PanGEO
INCORPORATED
Geotechnical & Earthquake
Engineering Consultants

April 4, 2019
Revised April 24, 2019
File No. 14-128.200

Subject: **Response to Geotechnical Review Comments (Revised)**
Proposed Single-Family Residence
4634 E Mercer Way, Mercer Island, WA

PanGEO INCORPORATED	Proposed Development 4634 E Mercer Way Mercer Island, Washington	SITE AND EXPLORATION PLAN	
		Project No. 14-128	Figure No. 1

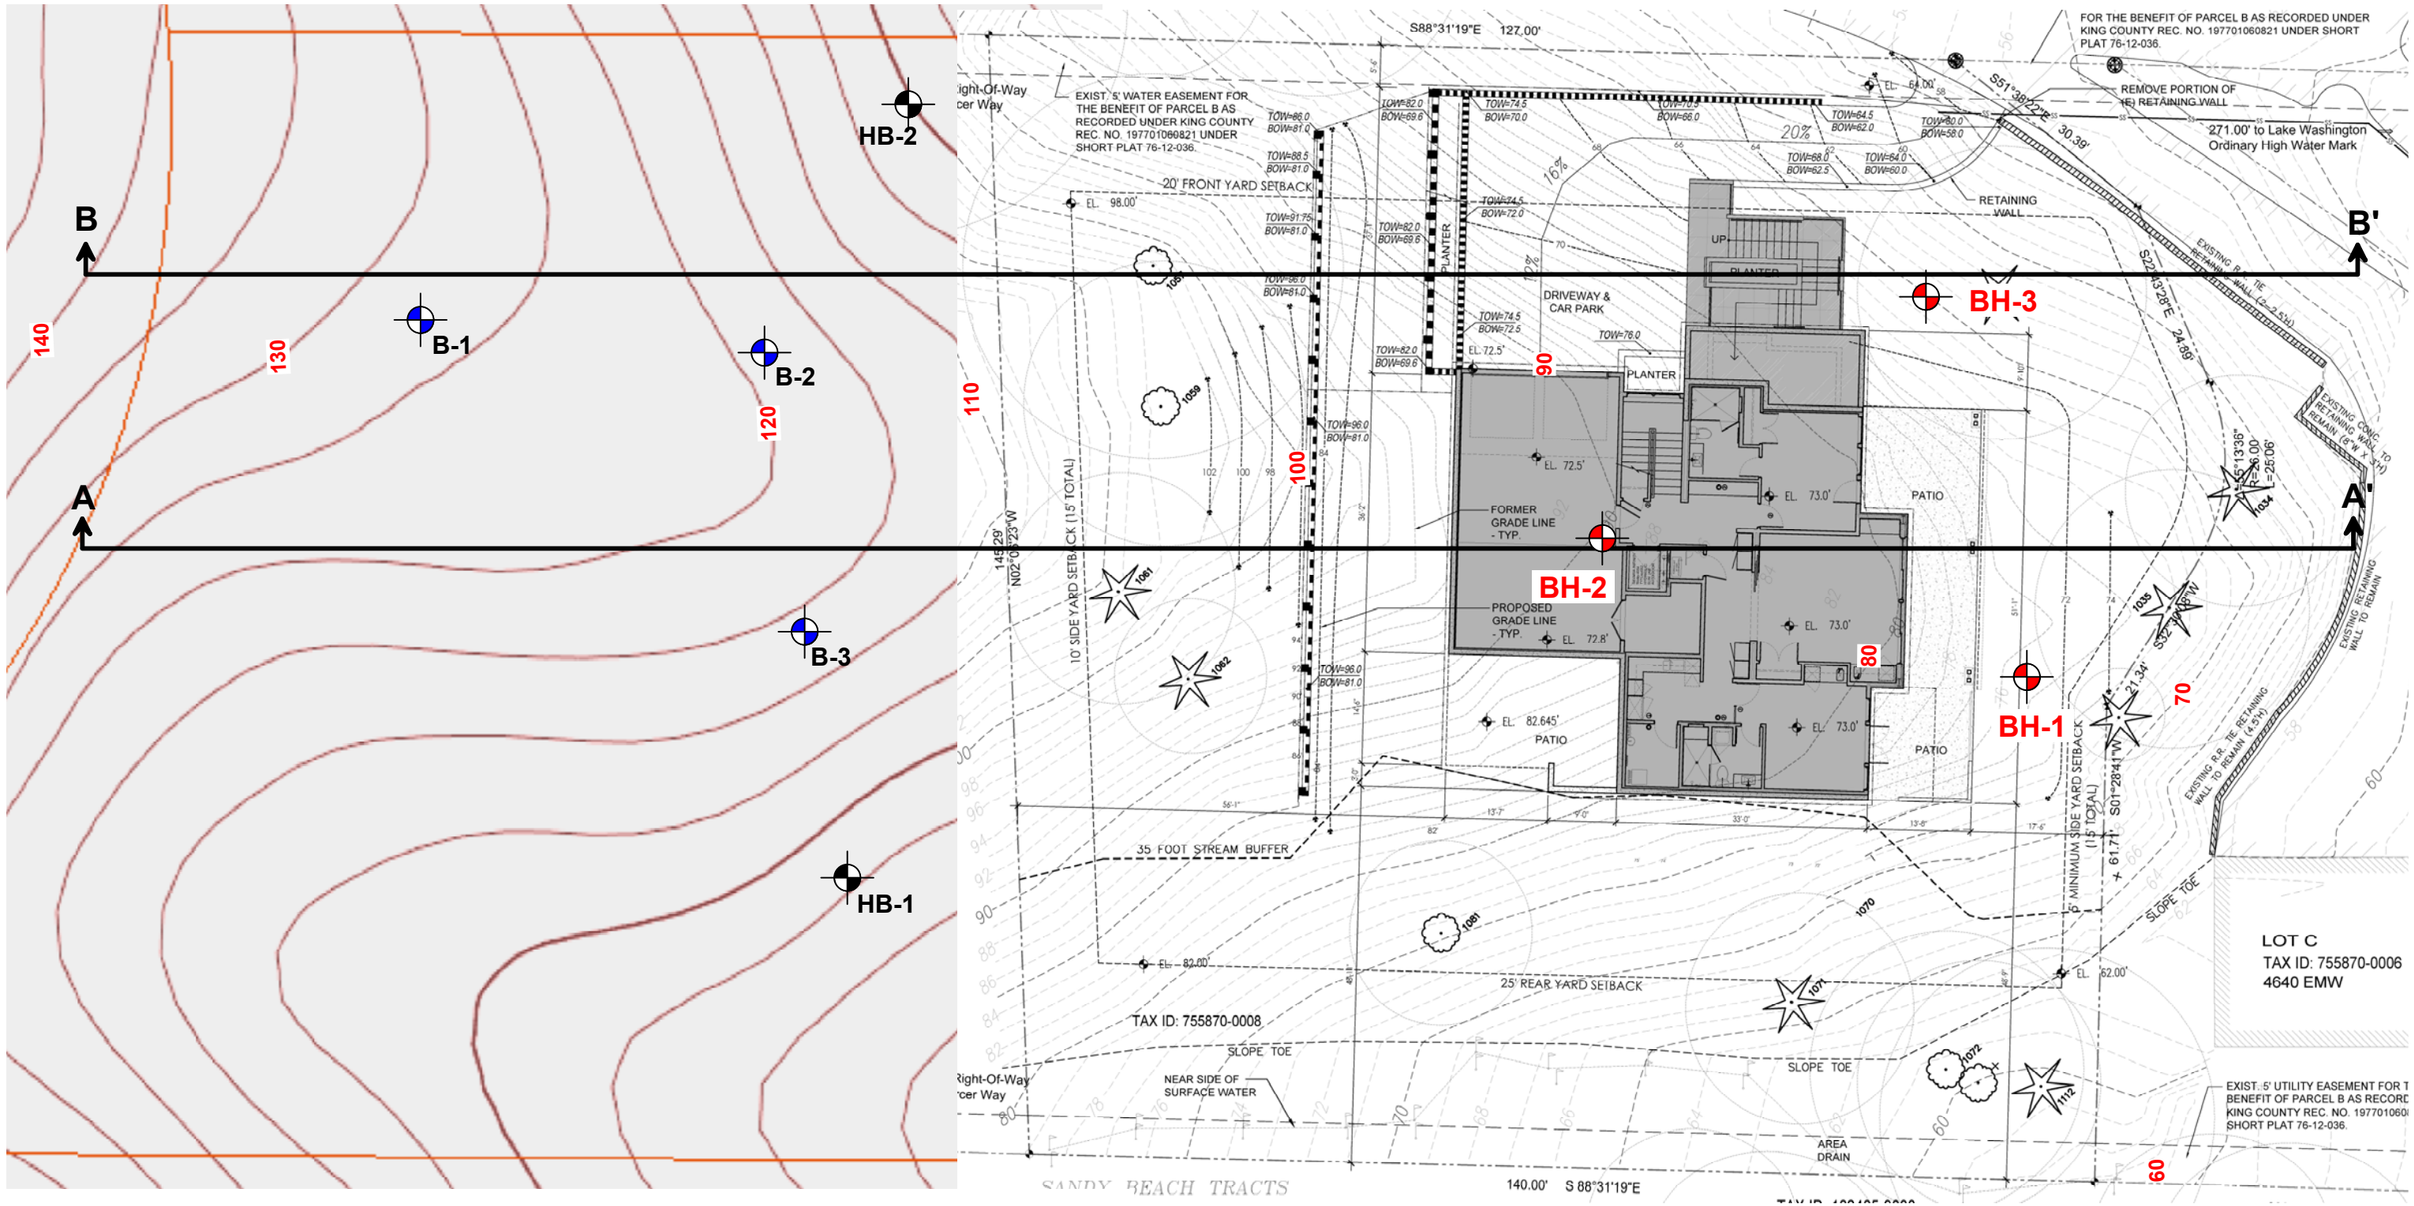
1. Subsurface Conditions (Comment #1)

pile walls. The approximate boring locations are shown on Figure 1. The Figure 1 includes the adjacent property to the west to show the existing borings. The summary boring logs are included in Appendix A for reference. Based on our current review, we may have incorrectly assigned geologic unit for medium dense sand below 4 feet in boring BH-1 and BH-2 as Colluvium. We believe that it is more appropriate to describe as Weathered Pre-Olympia Deposit).

During our current effort, we collected and reviewed the existing boring boring data on the adjacent property to the west (4630 East Mercer Way) competed by Agra Earth & Environmental in 1999. The existing exploration on 4630 E Mercer site consisted of three test borings and two hand borings. These existing borings generally encountered approximately 4 feet of loose to medium dense silty sand overlying medium dense to very dense silty sand and very stiff sandy silt that extended to a maximum exploration depth of about 11½ feet. Groundwater was not encountered within the drilling depths in the previous borings. The approximate locations of the previous borings and hand borings are also shown on Figure 1. The summary logs of the previous borings and hand borings are included in Appendix B for reference.

Based on the numbers of borings at the subject adjacent sites and consistent soil conditions encountered in the borings, it is our opinion that the available subsurface data is sufficient for additional geotechnical analysis, and additional borings are not necessary.

GENERALIZED SUBSURFACE PROFILE
SECTION A - A'

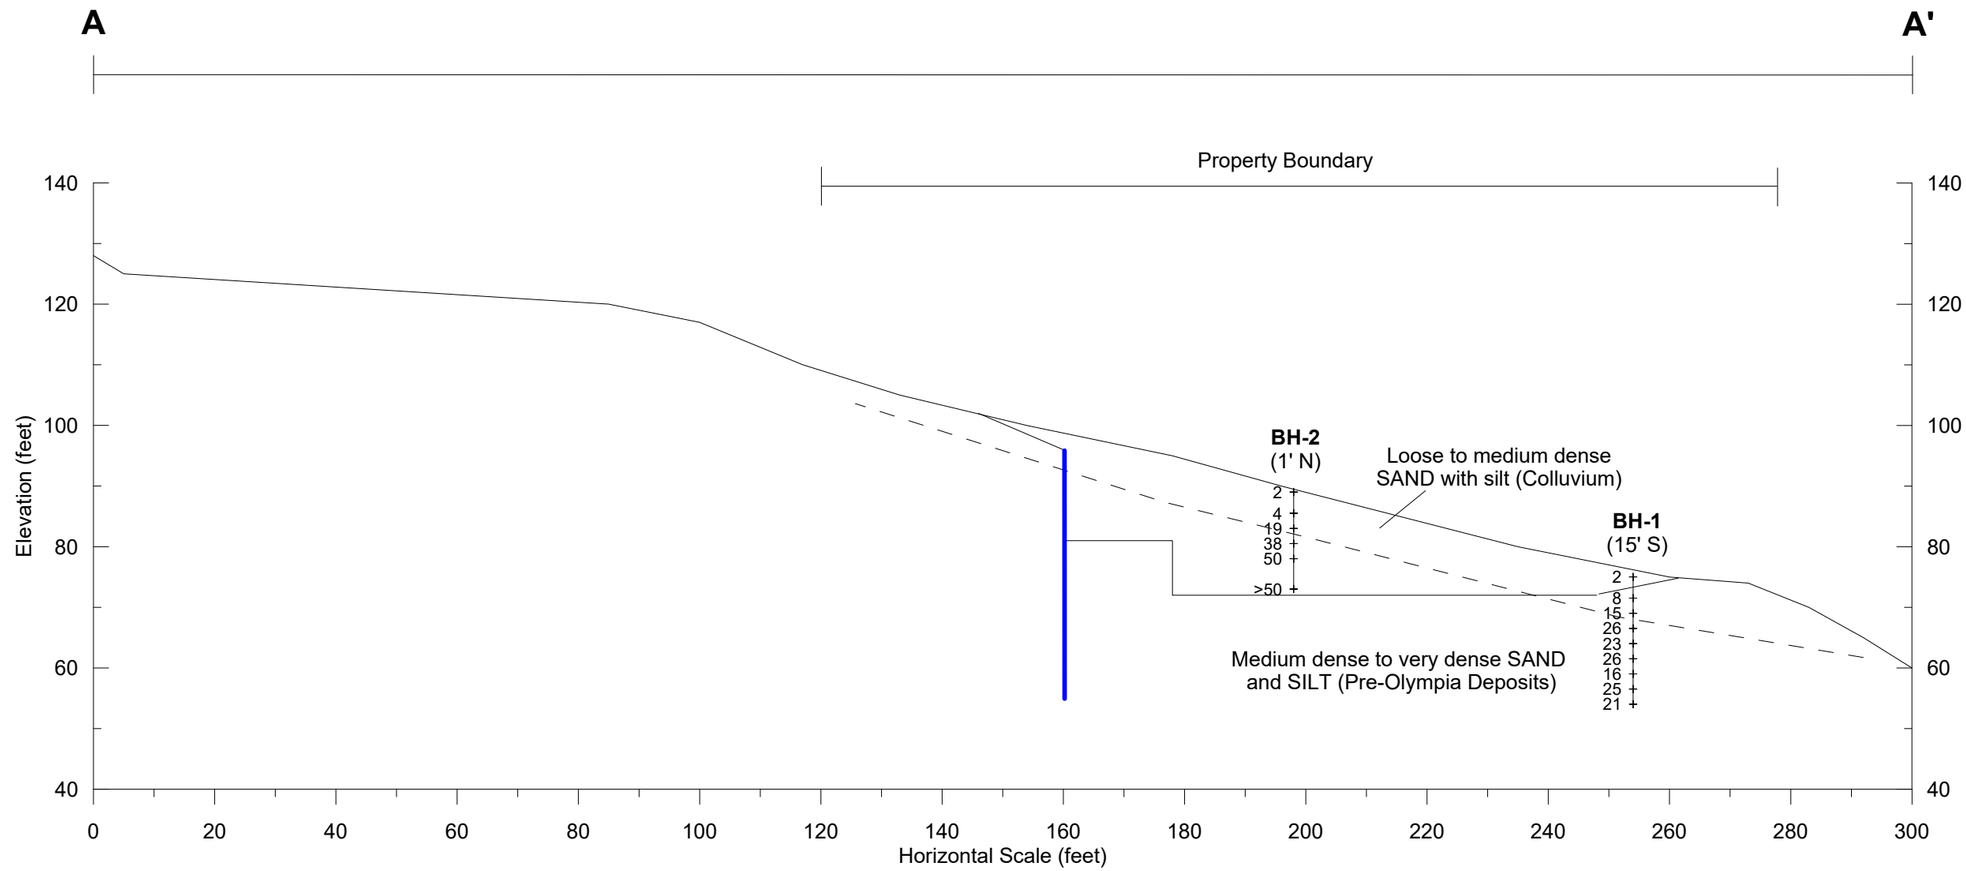
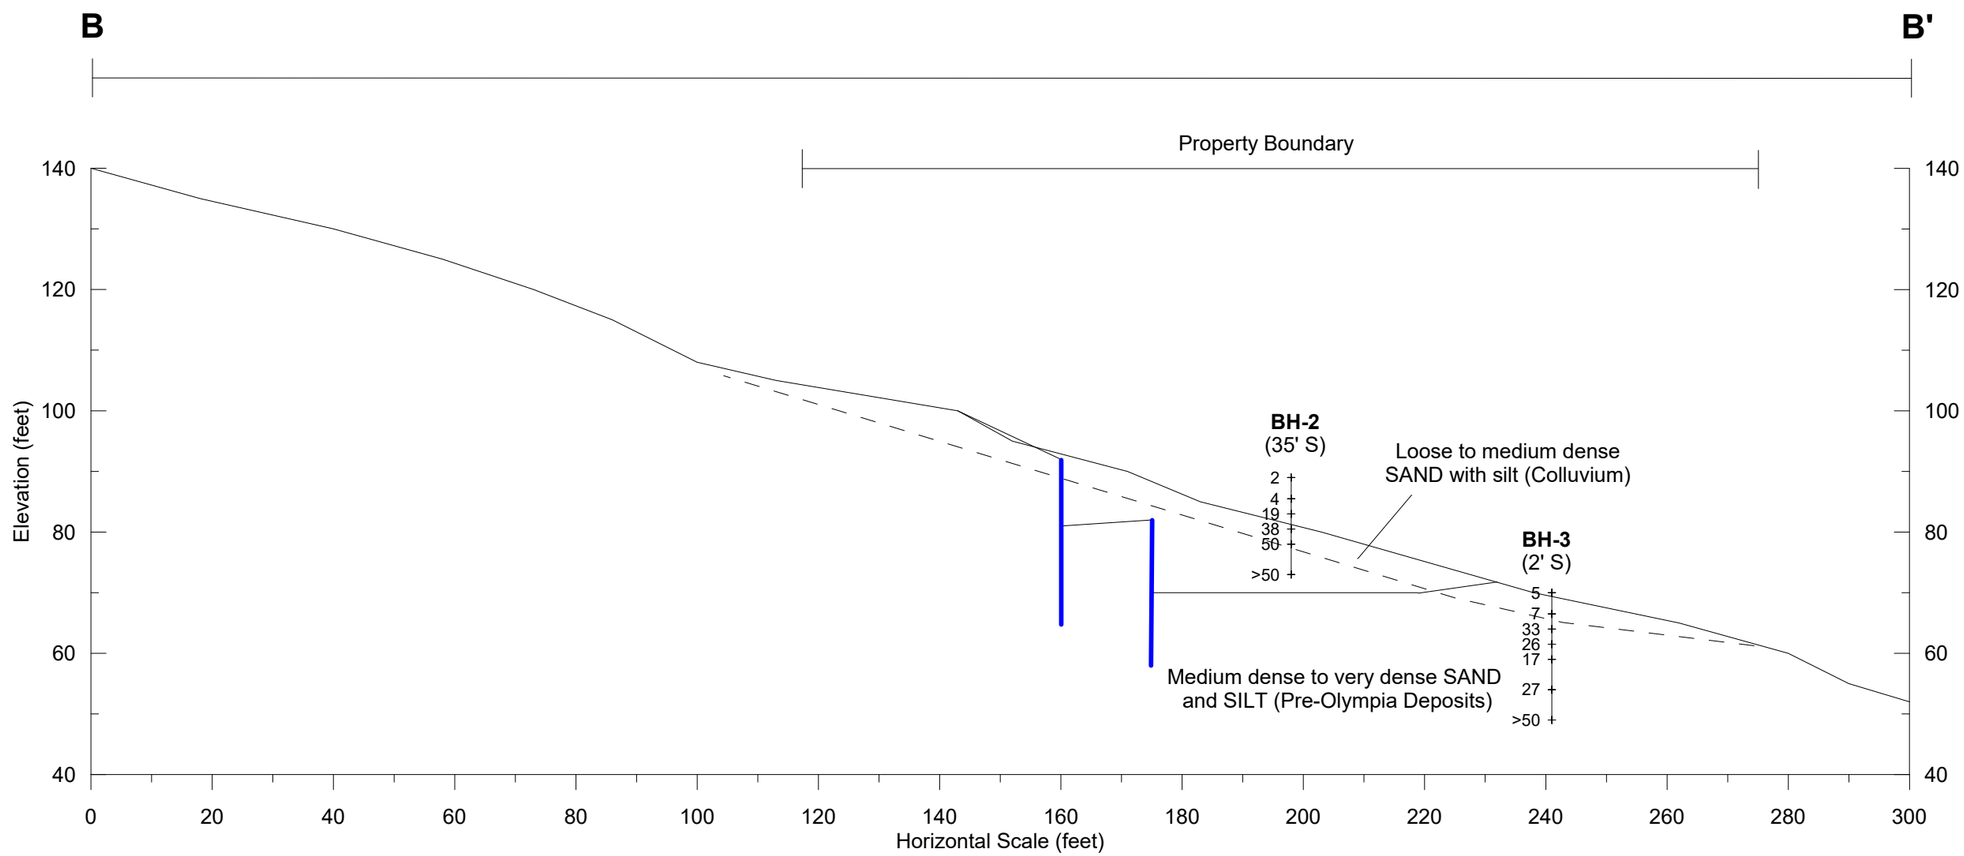
2. Overall Slope Stability analysis (Comment #2)

Two cross sections, A-A' and B-B, were created for the slope stability analysis. The approximate locations of the cross sections are shown on Figure 1. These two cross sections appear to be similar profile. As a result, the cross section A-A' was used for slope stability purpose, assuming a solider pile embedment depth of 14 feet (ie. soldier pile at B-B' condition).
